**RFT# 4262  
Boiler Replacement, Gym Heat Pumps,  
and Controls Upgrades  
Rocky Lake Elementary  
Addendum #2**

To: All Bidders

Date: May 14, 2025

**7) Reference Drawing M-102 Detail 2**

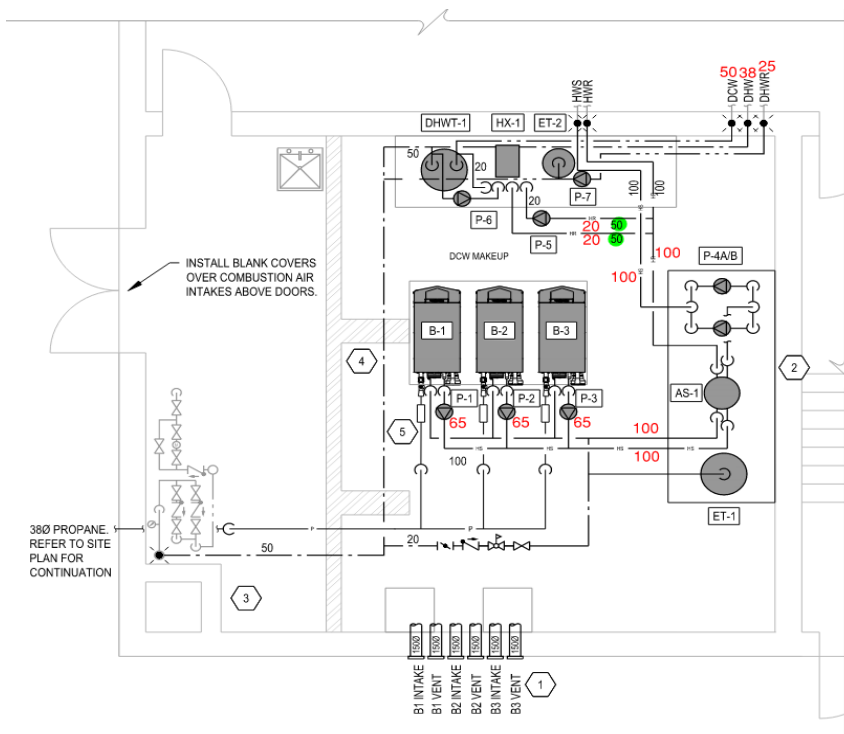
- a) Mechanical Room pipe sizing shall be updated as per the following sketch:
